Microcontroller Technical Information

Document No.	ZBG	-CD-10-0007	1/2	
QB-78K0RIX3 (Old Name: QB-78K0RKX3L)	Date issued	Janu	ary 25, 2010		
In-Circuit Emulator for	Issued by	Development Tool Solution Group			
78K0R/KC3-L, KD3-L, KE3-L, IB3, IC3, ID3, IE3		Multipurpose Microcomputer Systems			
		Microcomputer Operations Unit			
Usage Restrictions		NEC Electronics Corporation			
Related documents	Notification		Usage restriction		
QB-78K0RIX3 User's Manual: U19228EJ1V0UM00	classification		Upgrade		
QB-78K0RIX3 (Old Name: QB-78K0RKX3L)			Document modification		
In-Circuit Emulator for 78K0R/KC3-L, KD3-L, KE3-L, IB3, IC3, ID3, IE3 Upgrade: ZBG-CD-10-0008			Other notification

QB-78K0RIX3 (Old Name: QB-78K0RKX3L) In-Circuit Emulator for 78K0R/KC3-L, KD3-L, KE3-L, IB3,

IC3, ID3, IE3 - Usage Restrictions

No. 6 Restriction on trace data when an interrupt occurs (1)

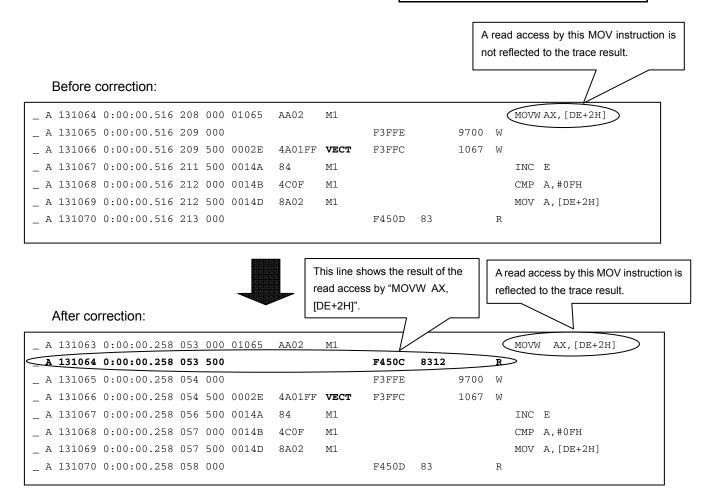
If a read access or write access is performed immediately before occurrence of an interrupt, this access might not be reflected to the trace result.

An example of trace data before and after the correction of this restriction is shown below.

This issue has been corrected in QB-78K0RIX3 with control code D.

No. 9 Restriction on trace data when an interrupt occurs (2)

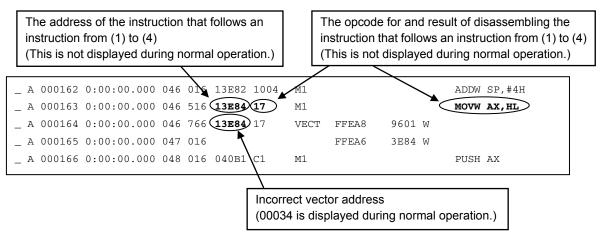
If interrupt servicing is executed under a specific condition, the trace result might be incorrect.

If execution jumps to an interrupt vector immediately after executing one of the above instructions, the instruction that follows the above instructions is not supposed to be executed or displayed in the trace result. However, due to this problem, the following items are displayed in the trace result:

- The instruction that follows the above instructions
- The incorrect vector address

An example of trace data before and after correcting this restriction is shown below.

This issue will be corrected in the next revision.
